BID ADDENDUM #2

Date: July 28, 2025

Project: RUHS Cardiac Catheterization Lab Suite & Hyperbaric Facility Expansion

Re: Bid Addendum #2

A3 NEW ROOF ACCESS DOOR INFILL - SILL & THRESHOLD
SCALE: 6" = 1'-0"

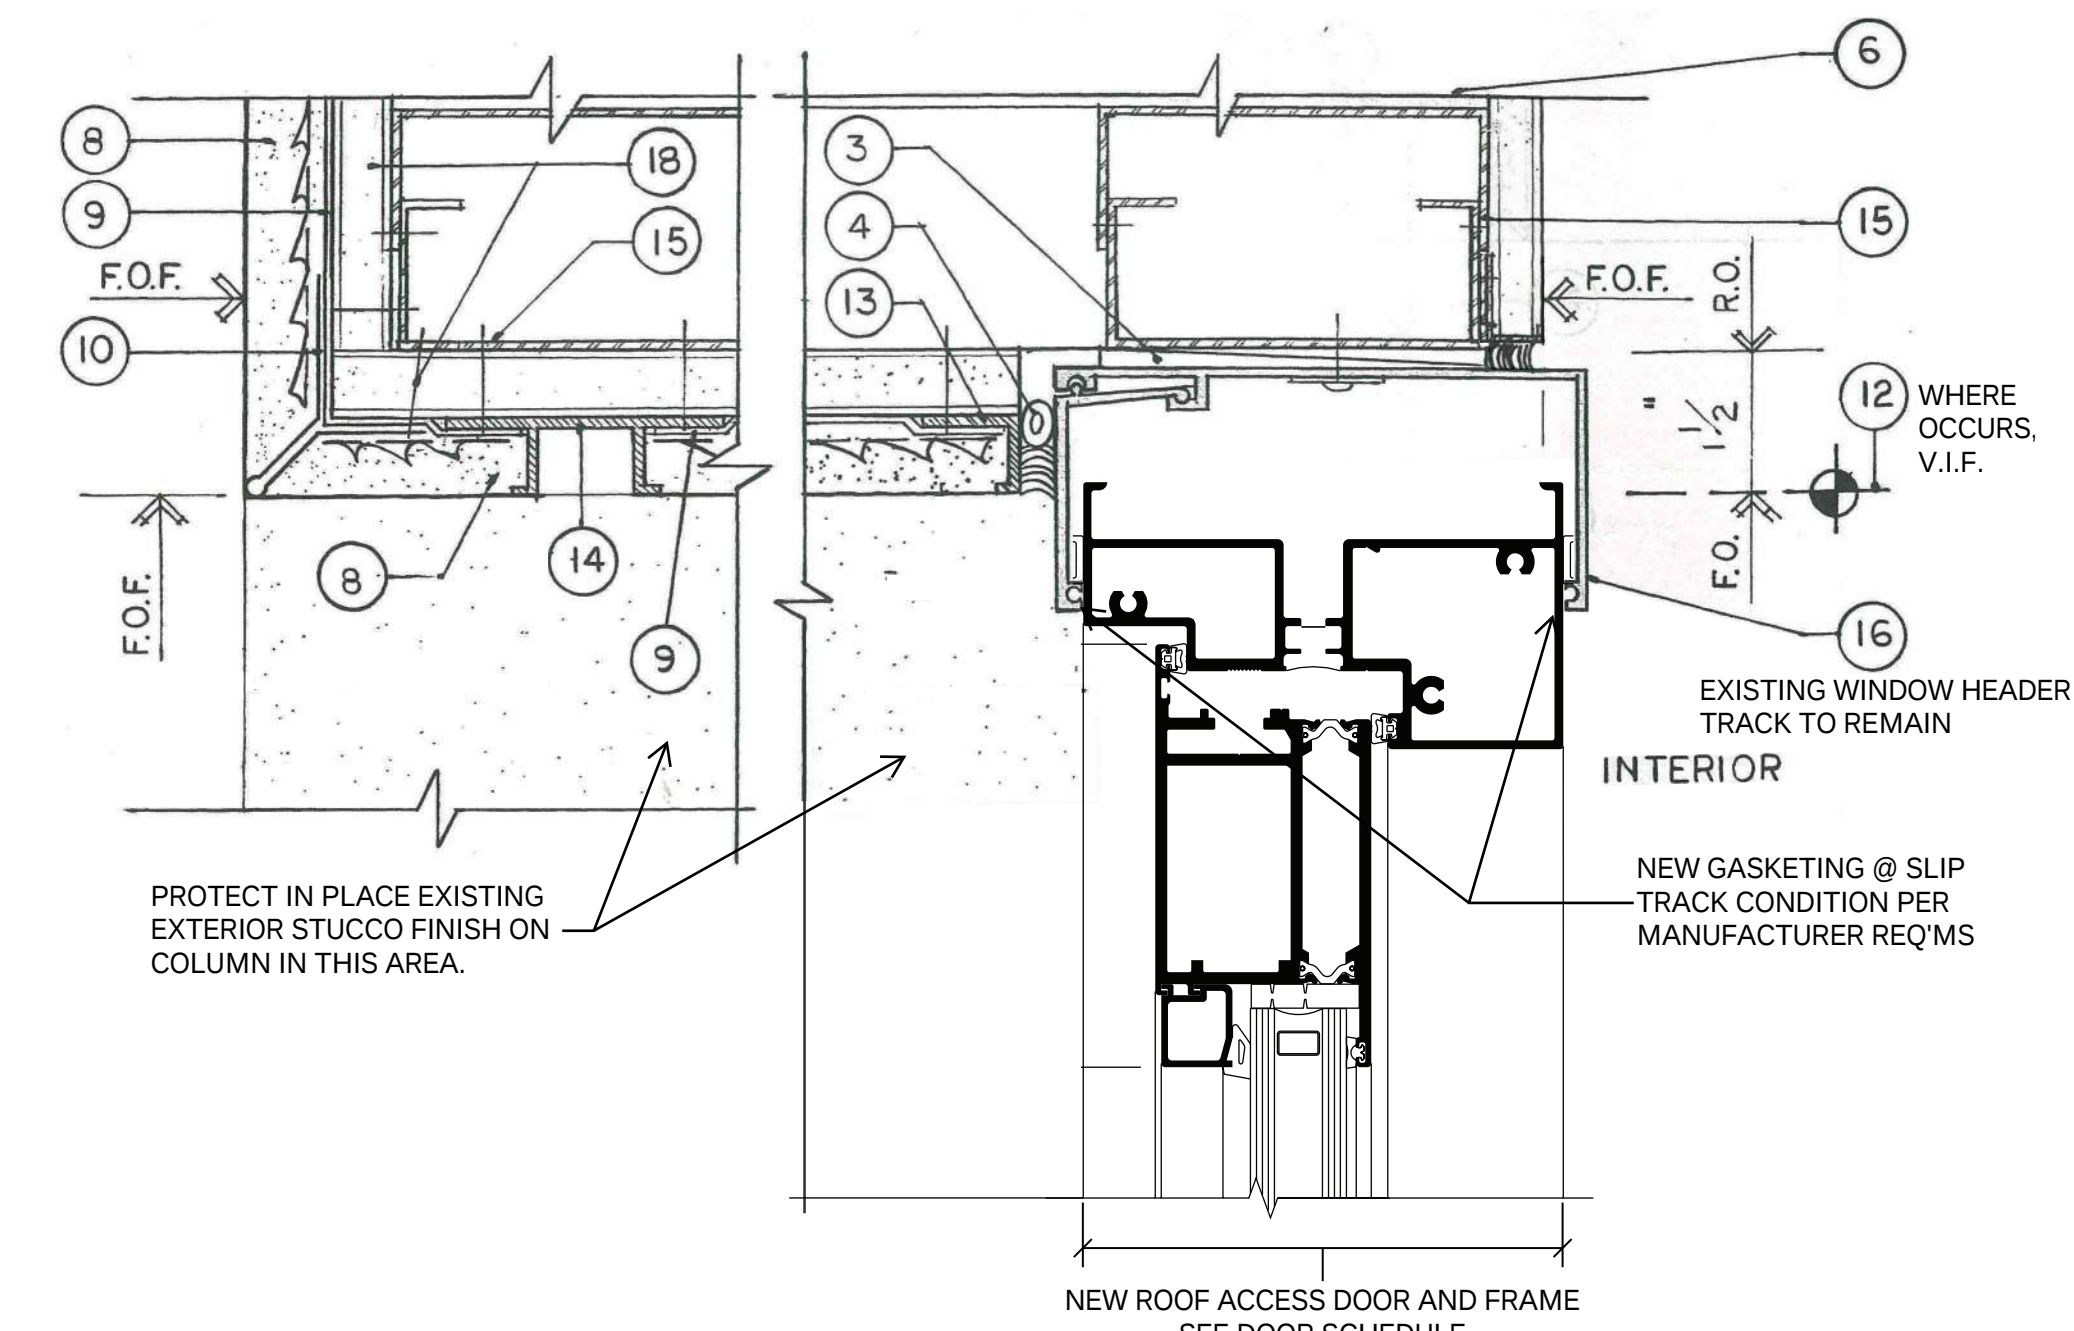
2. New demo plans and details describing the demo of an existing roof access hatch in the existing exterior storefront window and a portion of the exterior furred wall below the window.
3. New remodel plans and details describing the installation of a new roof access doorway within a single window bay of the existing exterior window system.

AE601

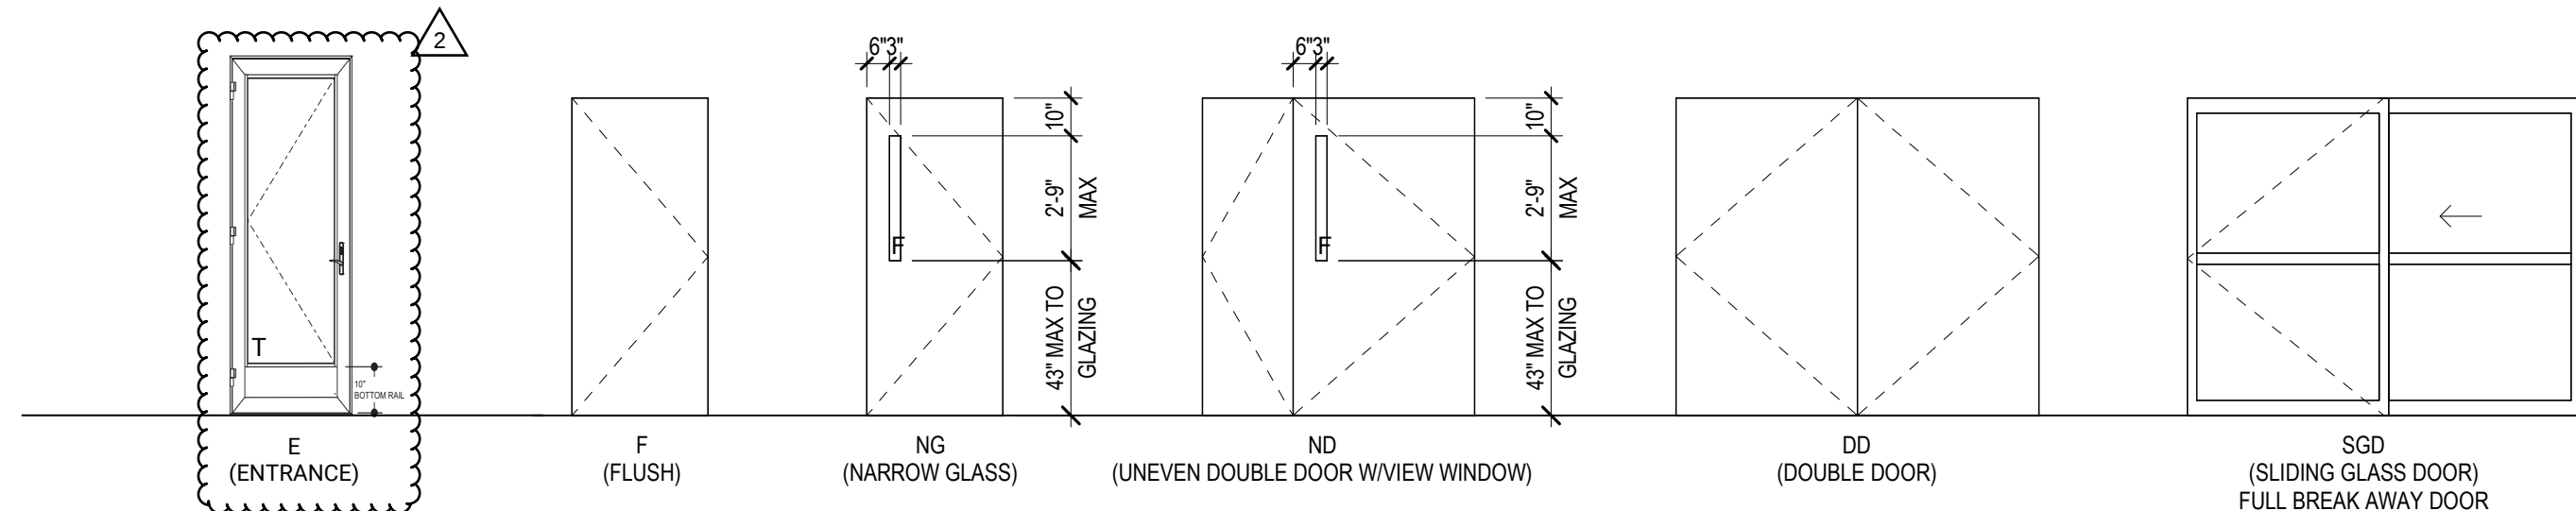
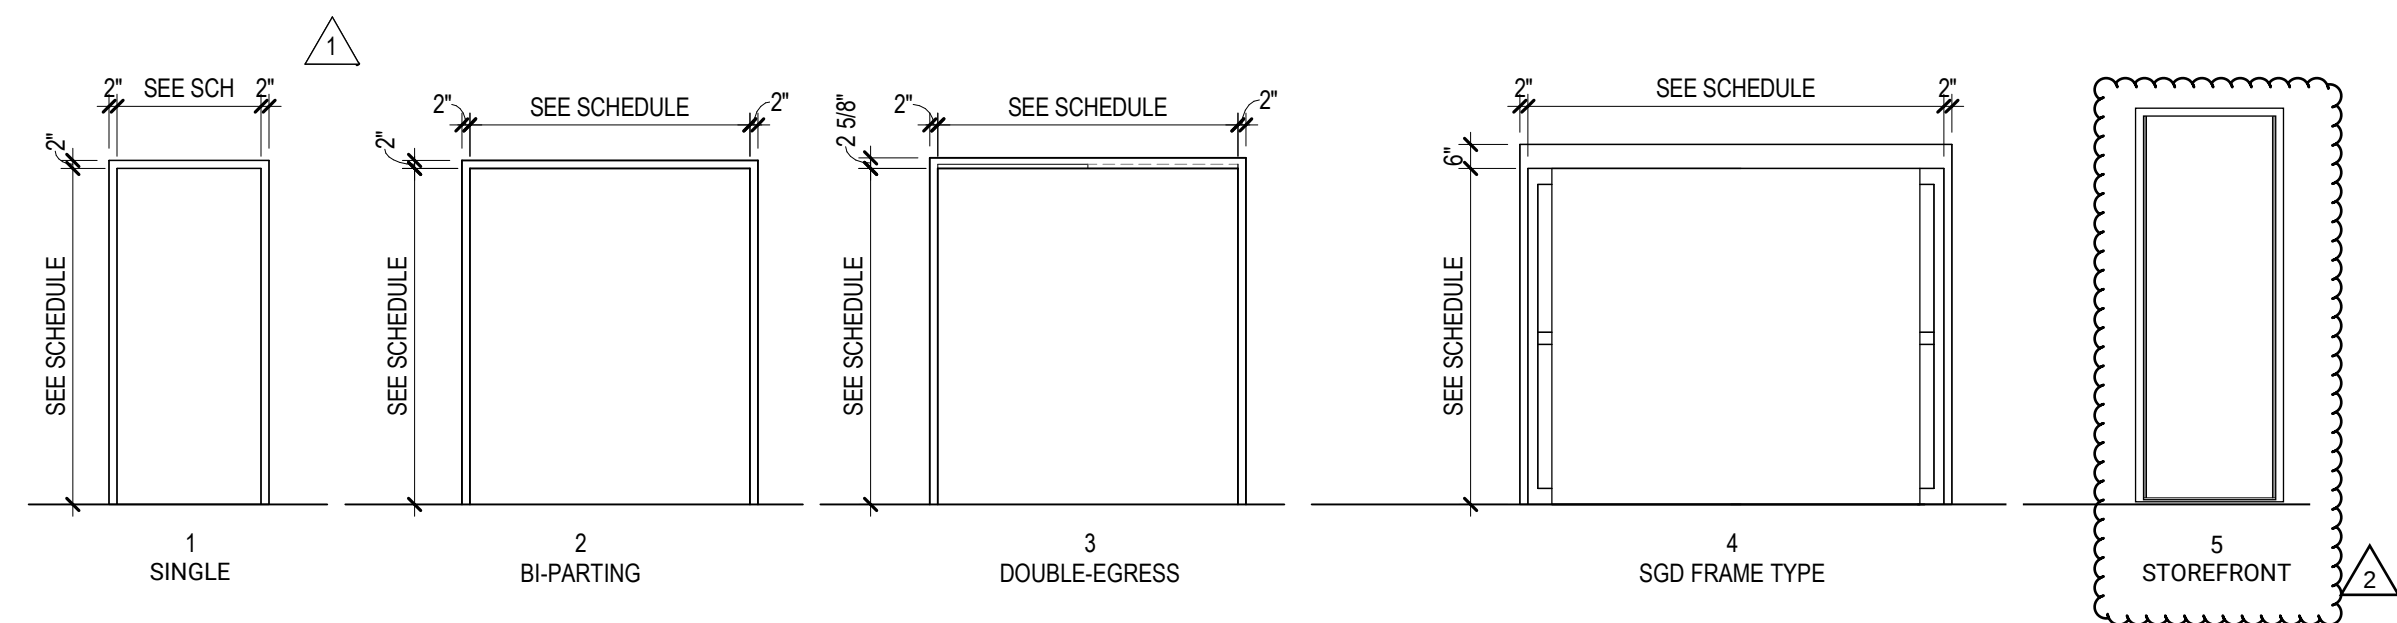
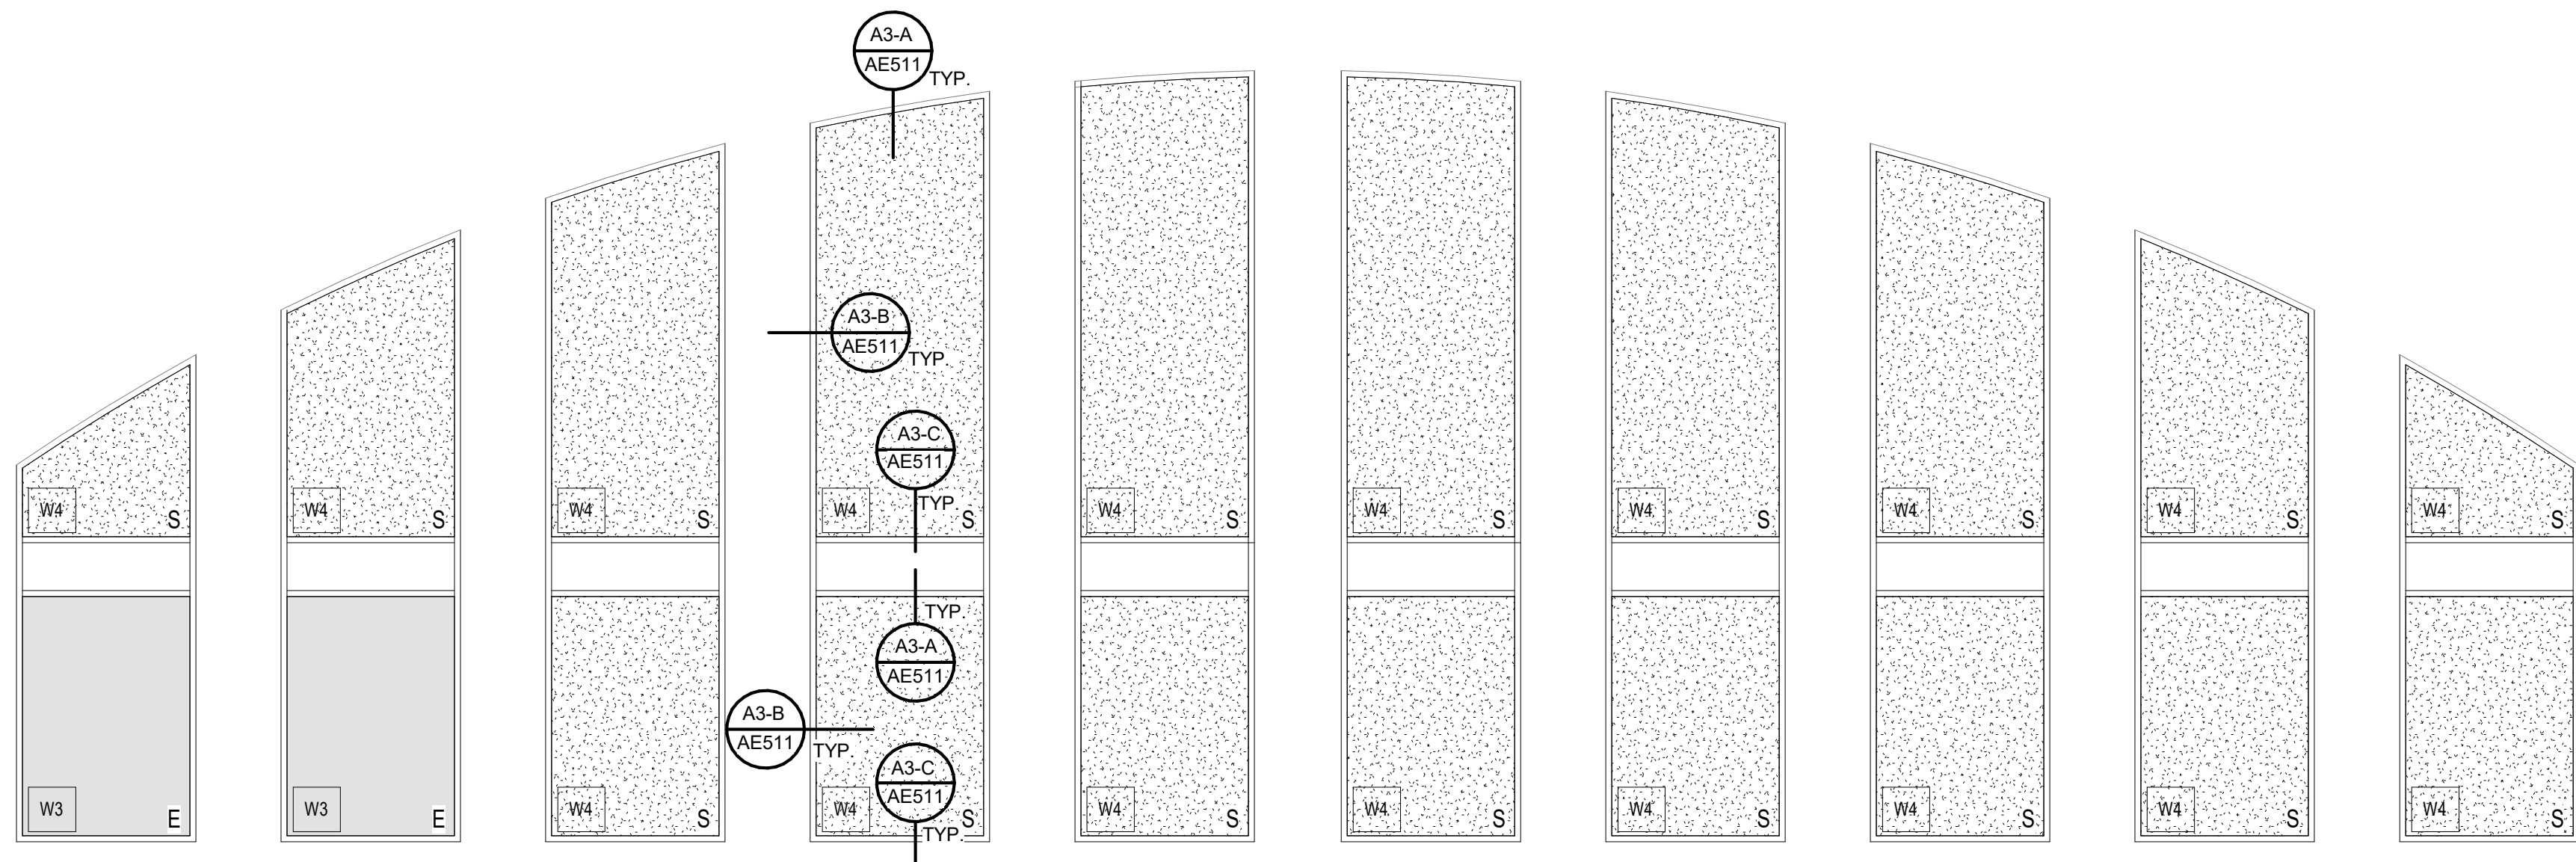
4. Added door E3002A to door schedule.
5. Added new Door Type 'E'
6. Added new Door Frame type 5.
